October 9, 2025

Project No. 2401284

**Re: Peer Review Comment Response
Maximum Predicted Water Table and Hydrogeological Assessment Report
Proposed Class 'A' Pit Above Water (JT Pit), JT Excavating Ltd,
Municipality of West Grey, Grey County**

Technical Memo

Figure No. 1

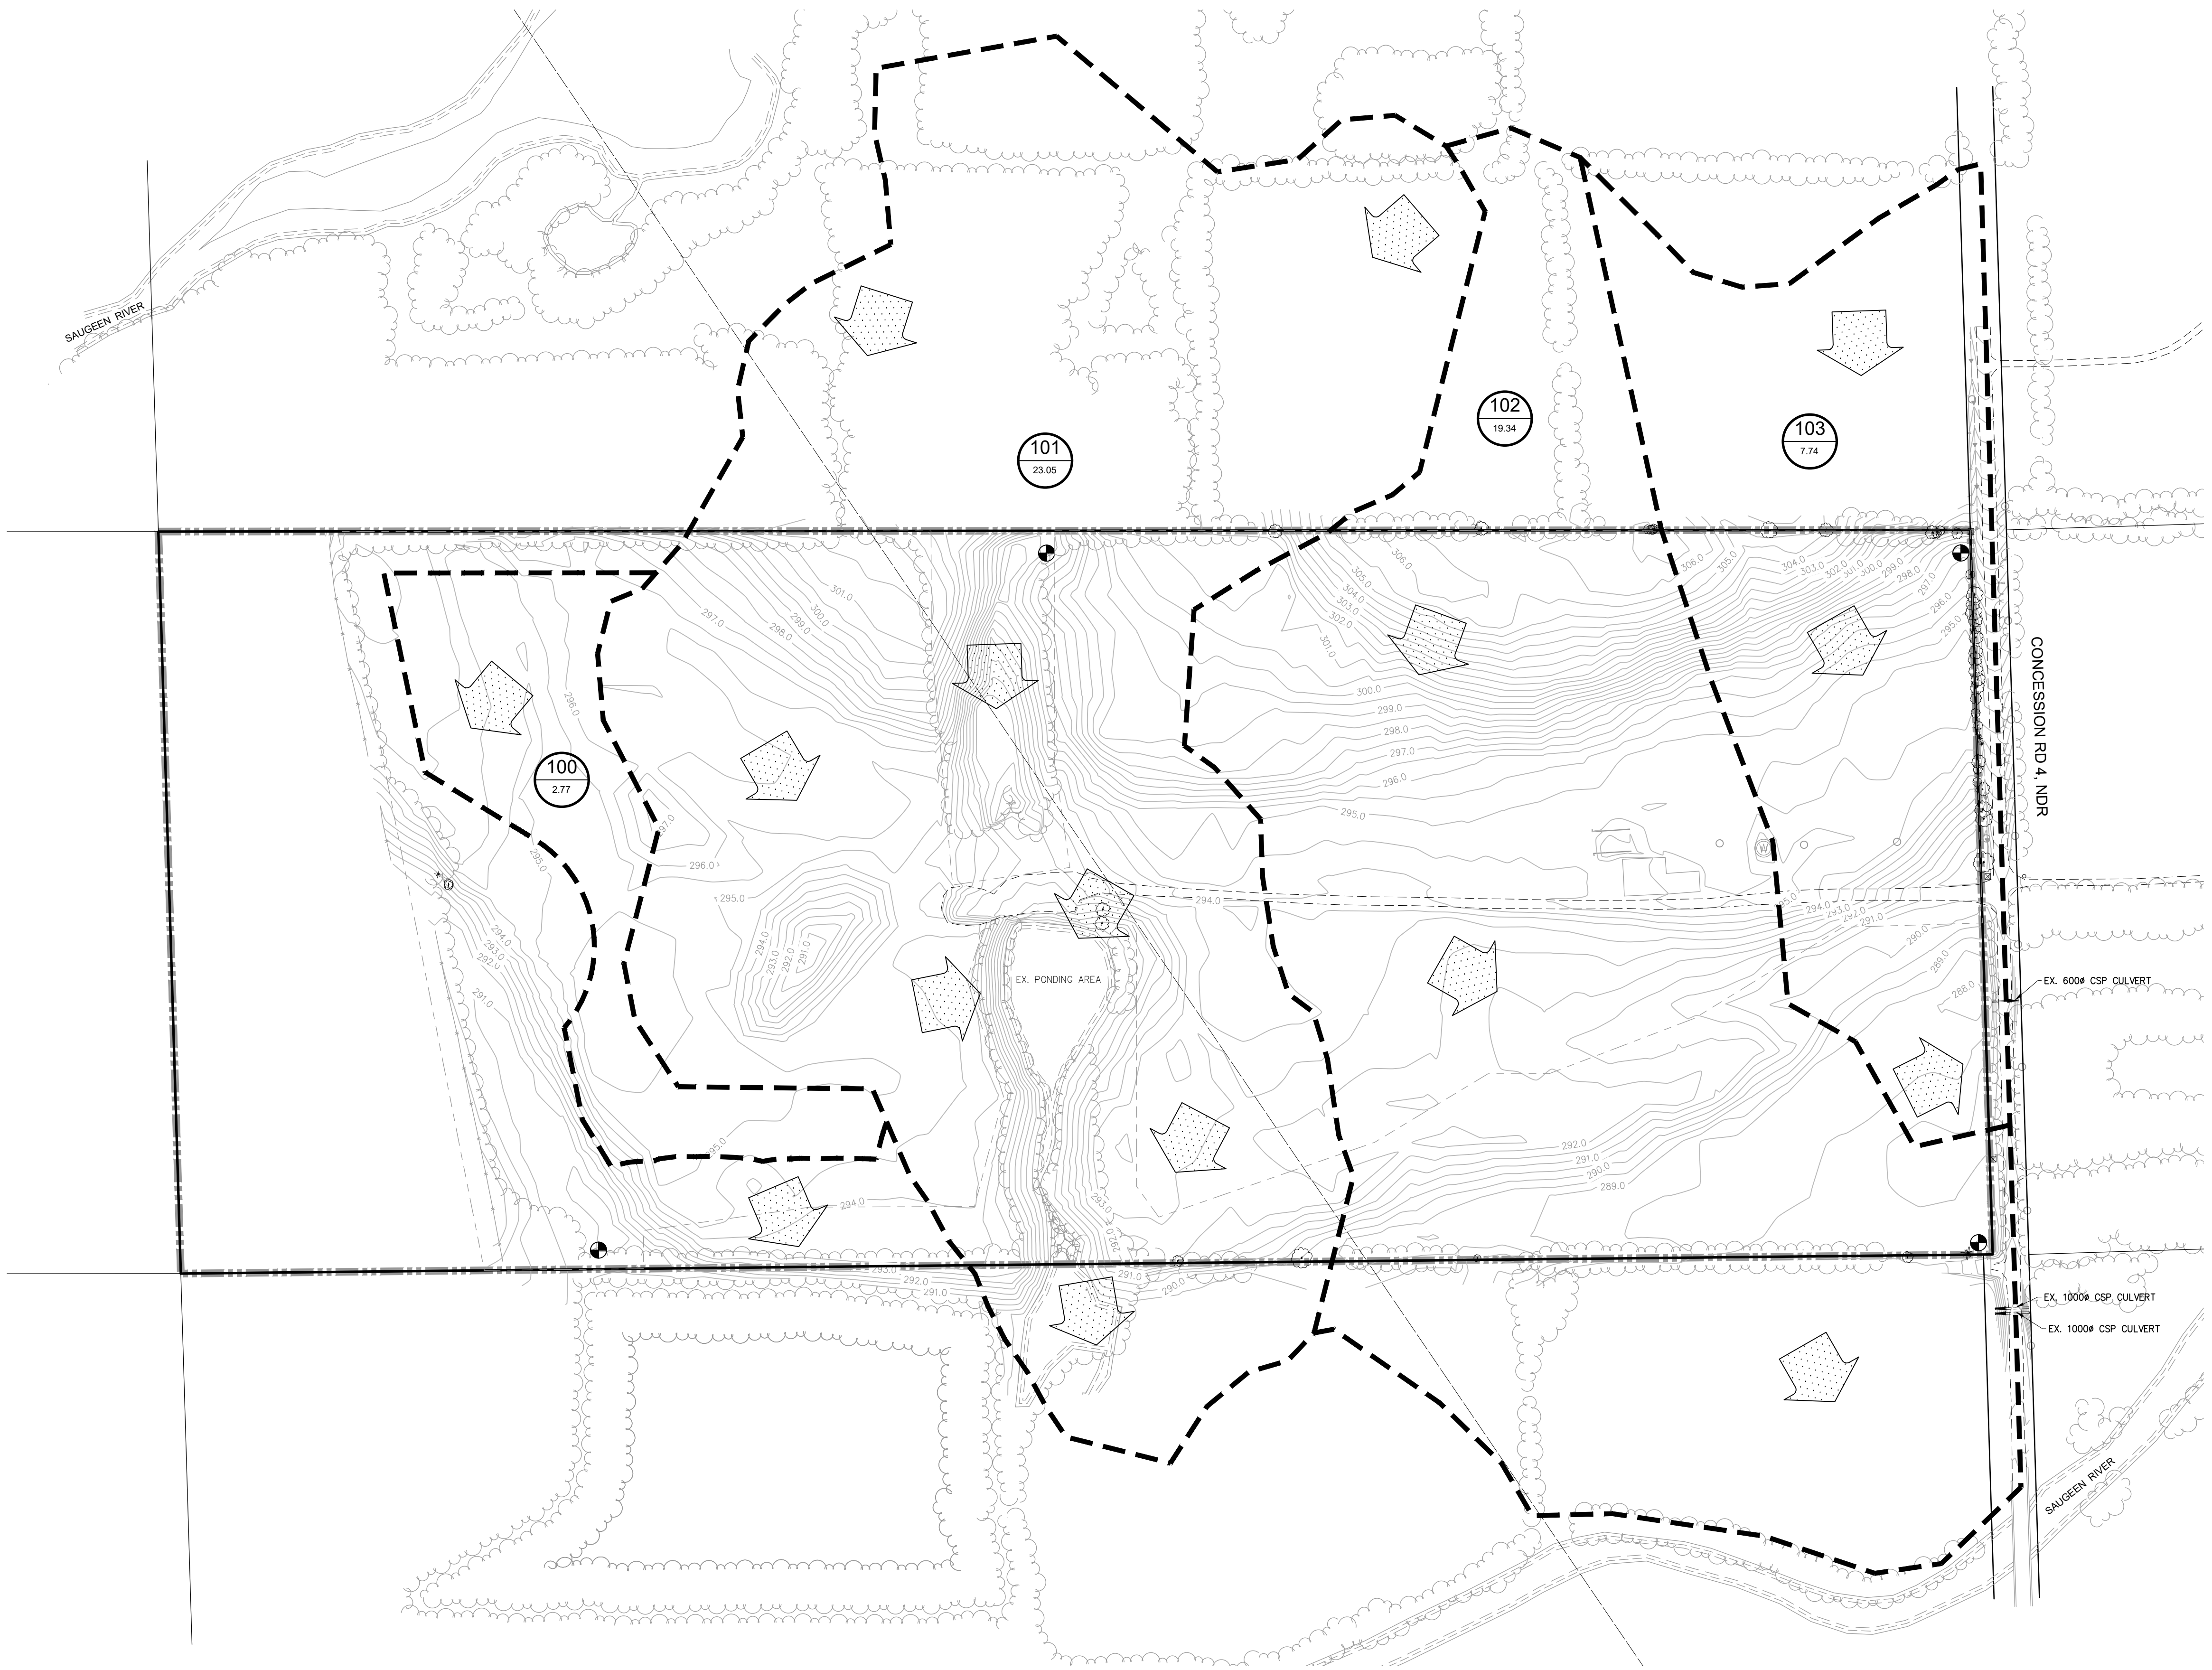
With respect to the last sentence in the above response, it was not clear to us what was meant by "proportionally", but the drainage arrows shown in catchment 103 on Figure 1 indicated that under existing conditions overland runoff from that catchment area would flow to the 600-mm diameter culvert beneath Concession 4 NDR, where it would presumably discharge to the watercourse. The post-development drainage conditions shown on Figure 2 indicated that the area of catchment 103 would be reduced by the presence of the pit, which would presumably reduce the volume of runoff that would flow to the watercourse.

While the direction of surface run off will continue to be in a southwesterly direction, it is acknowledged that there will be some change to the overall runoff associated with the pit property. The post rehabilitation grading will maintain the overall direction of runoff; however, some amount of runoff will not discharge off site and will infiltrate on the property due to a “basin” effect from the final contours. There is a volume of water that will be captured in this small “basin” that will not run off the site. This volume of water was calculated to be 376,850 m³ per year based on the area of the excavation areas multiplied by annual precipitation and accounting for a portion of the water to evaporate. While this volume will no longer run off the site, it will infiltrate into the soil on the JT Pit property. The local groundwater flows towards the Saugeen River, the infiltrated water will travel as groundwater to the Saugeen River. It is our opinion that the water balance

PROGRESSIVE REHABILITATION PLAN

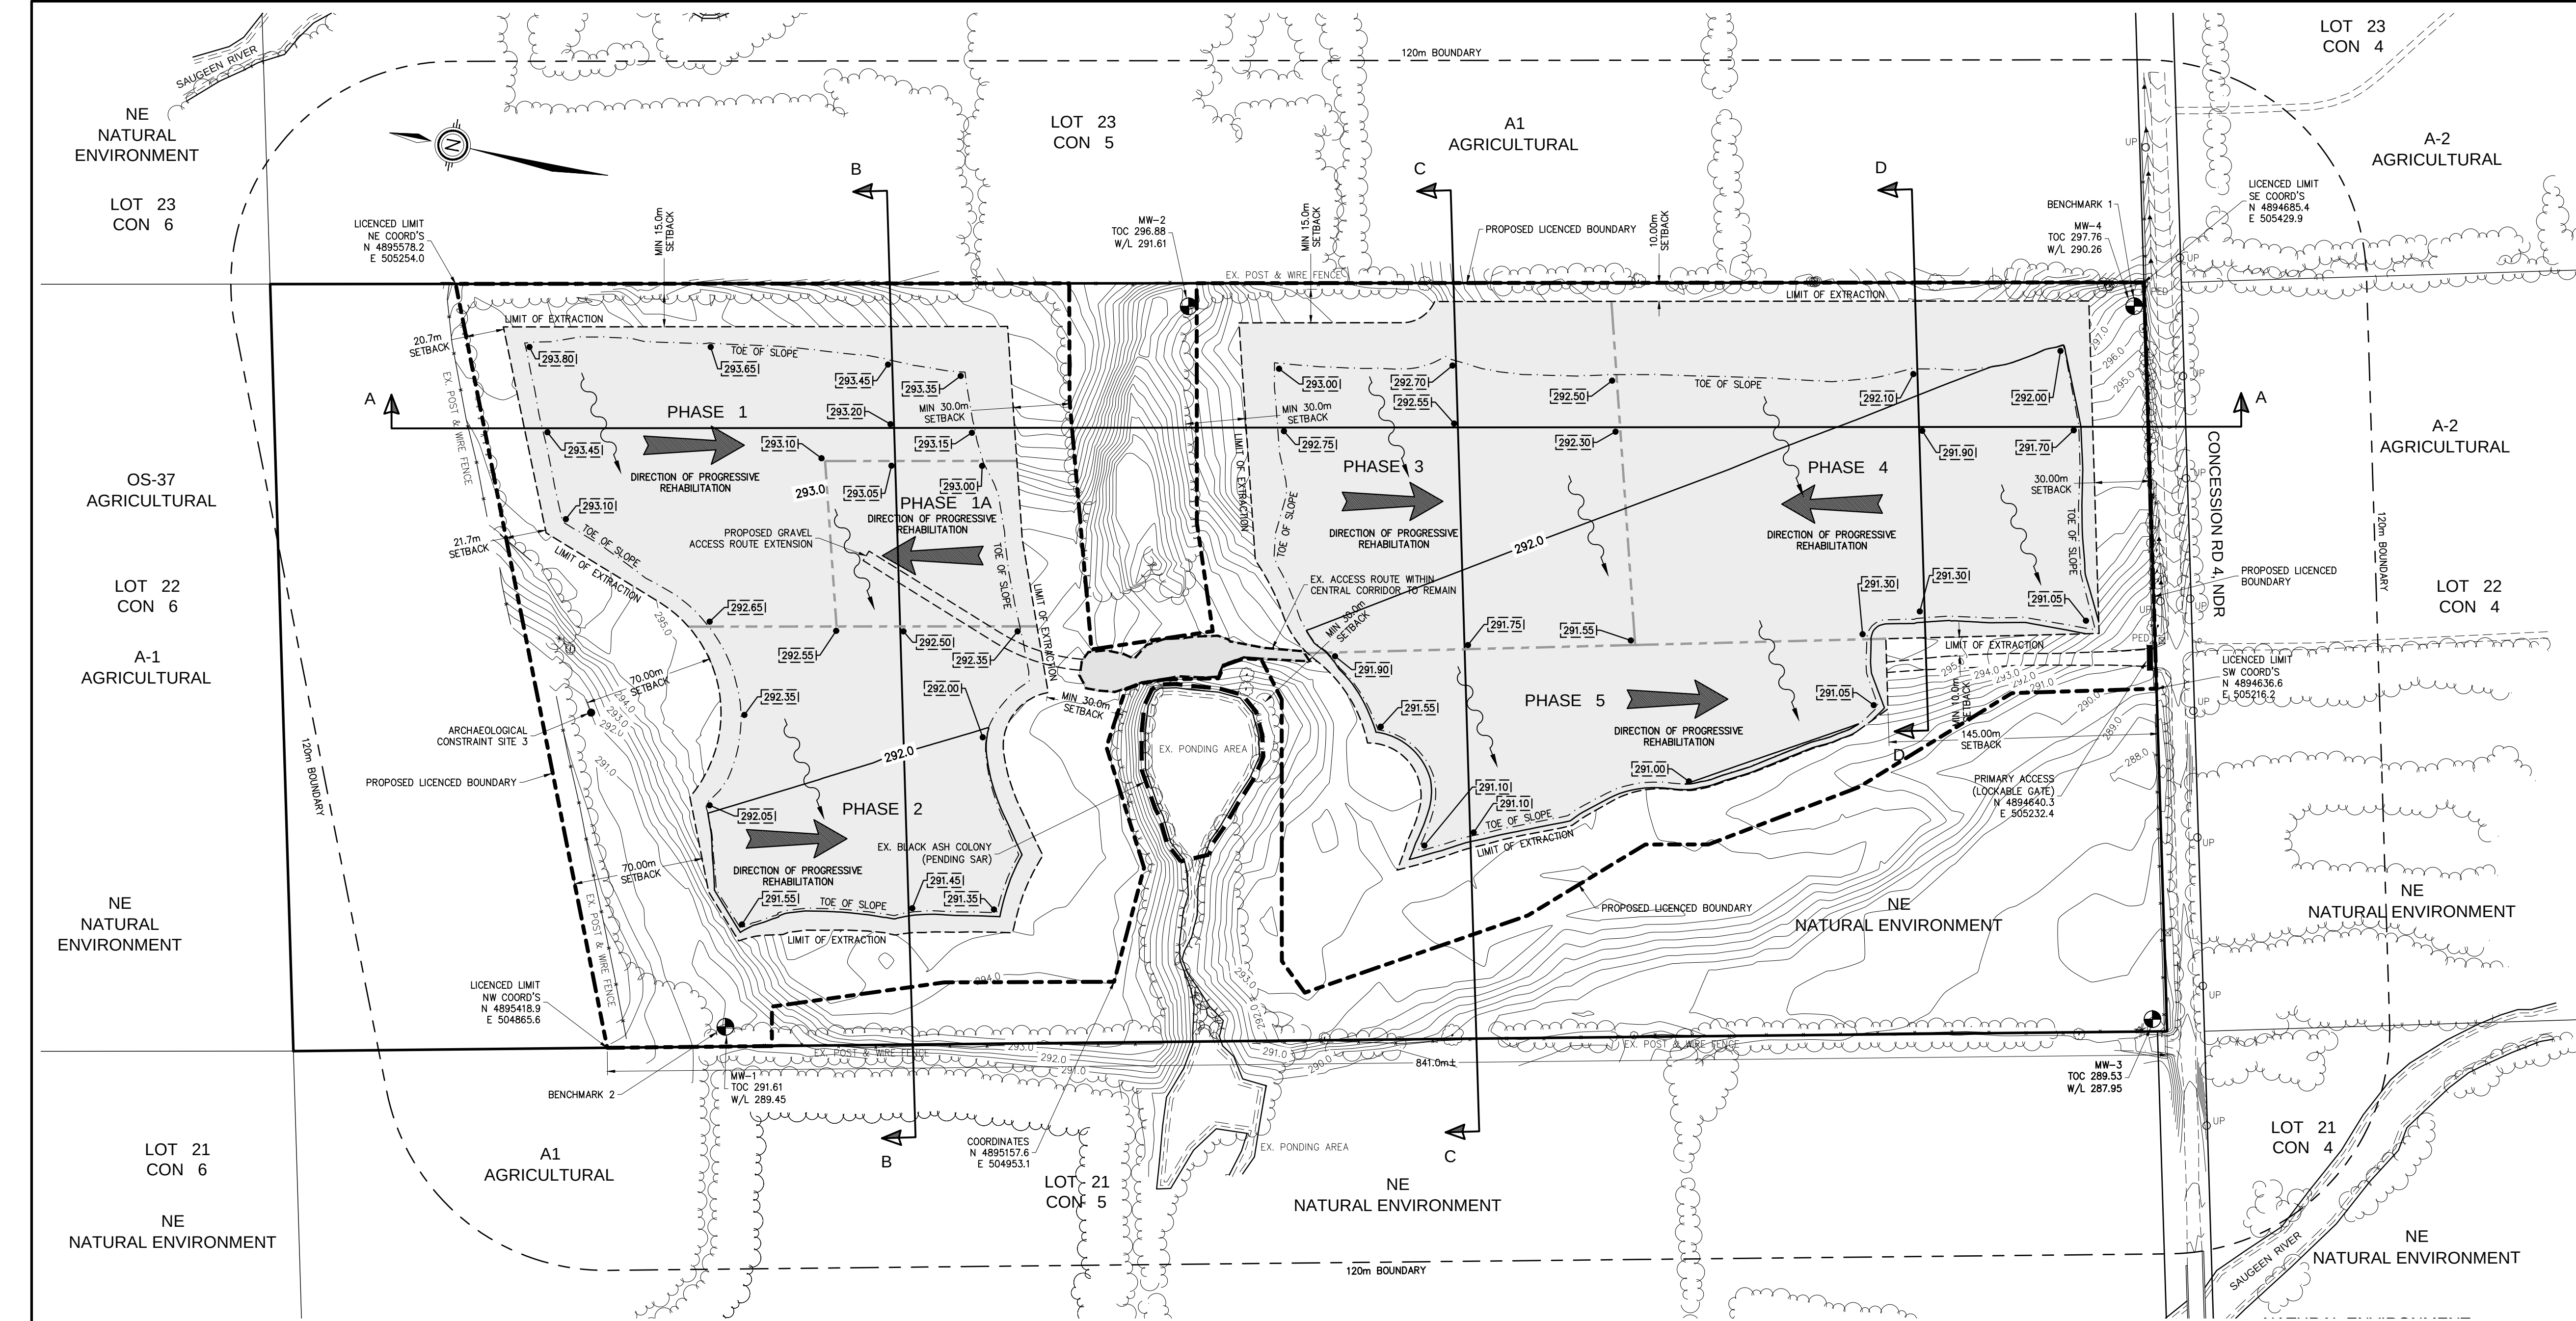
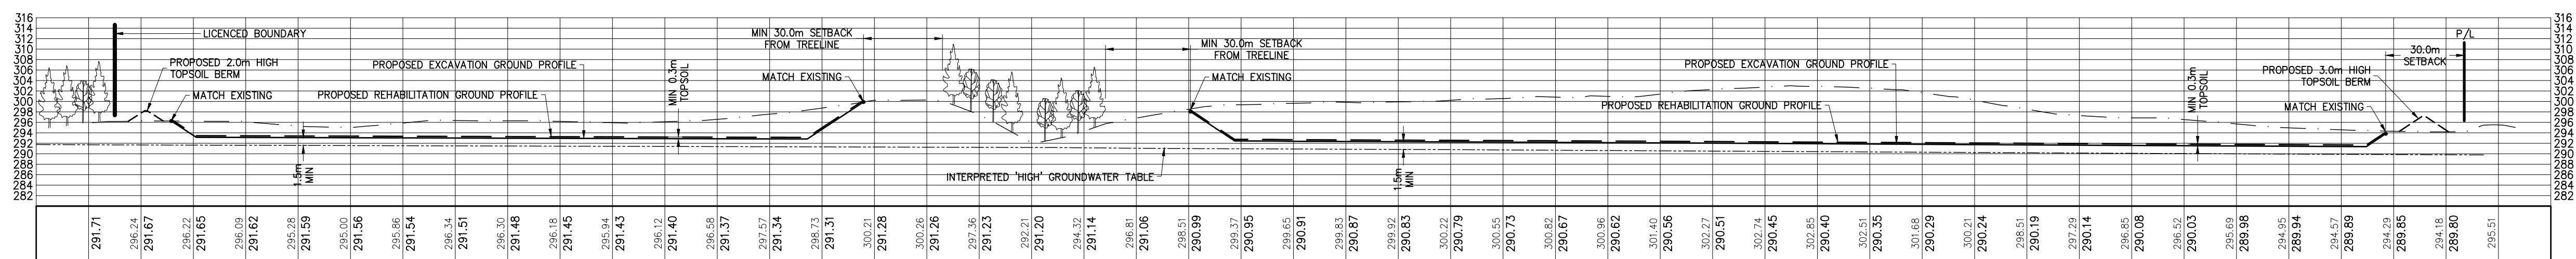
GSS Comment: The rate of post-development infiltration may be similar to the pre-development rate based on the consistency of soil type, but the volume of infiltration on an annual basis will change. The site plans indicated that two enclosed pits will be created in the north and south halves of the site. Notes on both the Operations Plan and the Progressive Rehabilitation Plan indicated that surface water drainage from those pits will be by percolation or evaporation, meaning there will be no runoff from those areas. The existing ground profiles shown on Sections B-B, C-C, and D-D on Drawing No. 4 indicated that there would be surface runoff to the west at the section locations under existing conditions. The proposed rehabilitation ground profiles shown on the same sections indicated that there would be no runoff beyond the western limit of the completed pits. Presumably, most of the volume of the current run-off from the 17.4-ha extraction area will become infiltration, with some potential for increased evapotranspiration. It is not conceivable to us that equal infiltration to the subsurface will continue post-development. We would consider the creation

We assumed that the GEI comment that the surface flow direction indicated by the arrows on Drawing No. 3 Progressive Rehabilitation Plan will continue to be northeast was intended to mean west-southwest. The direction of surface water runoff within the completed pit may be consistent with the pre-development direction, but the site plans indicated that there will be no runoff at the western limit of the pits, as there is under existing conditions, unless the runoff ponds to a sufficient depth in the pit to flow over the top of the completed slopes.

We assumed that the GEI comment that the surface flow direction indicated by the arrows on Drawing No. 3 Progressive Rehabilitation Plan will continue to be northeast was intended to mean west southwest. The direction of surface water runoff within the completed pit may be consistent with the pre-

development direction, but the site plans indicated that there will be no runoff at the western limit of the pits, as there is under existing conditions, unless the runoff ponds to a sufficient depth in the pit to flow over the top of the completed slopes.

The direction of surface water run off as indicated on Drawing No. 3 Progressive Rehabilitation Plan is south southeast, which is consistent with the direction of surface water run off indicated on Drawing No. 2.
